***Add the following variables to 33.3.3.3:***

**Add the following variables to 33.2.4.9:**

The PSE state diagram on the next page is the new state diagram as proposed by comment #87, not the SD as used in D1.5. If adopted, the changes in red are to be applied to comments #87.

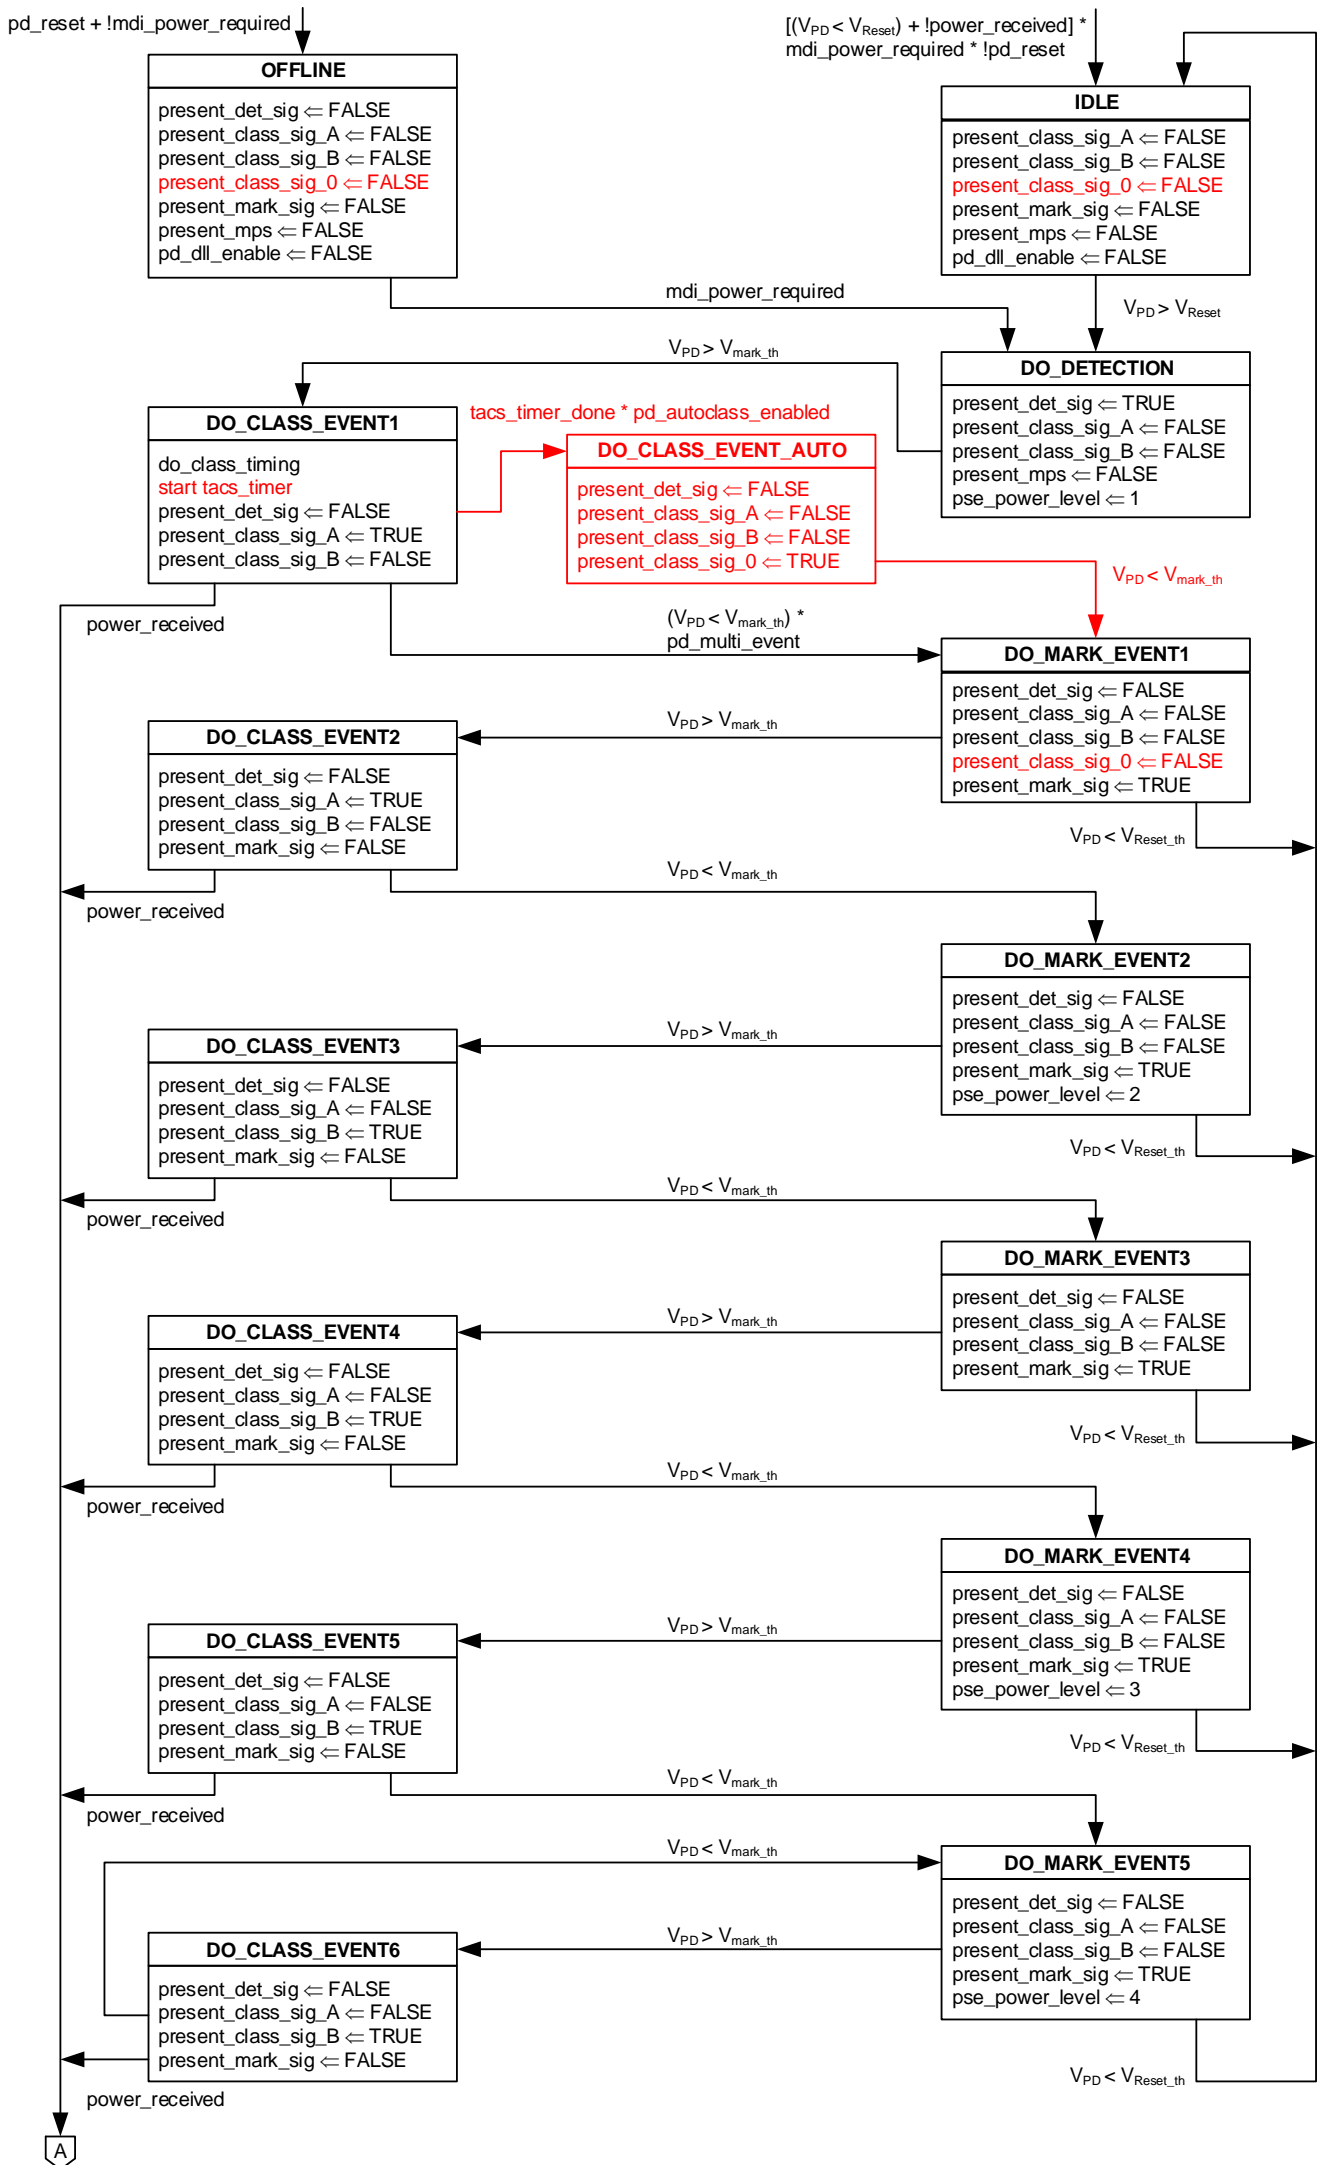
pd\_autoclass\_enabled

A control variable indicating that the PD is enabled to perform Autoclass by dropping its classification current during the first classification event (see 33.3.5.3).

present\_class\_sig\_0

Controls presenting classification signature '0' during T<sub>ACS</sub> of the first classification event (see 33.3.5.3).

tacs\_timer

A timer used to change the classification current to class signature '0' when a PD uses Autoclass; see T<sub>ACS</sub> in Table 33–18a.

***Make the changes to the state diagram as indicated in red on the next page.***
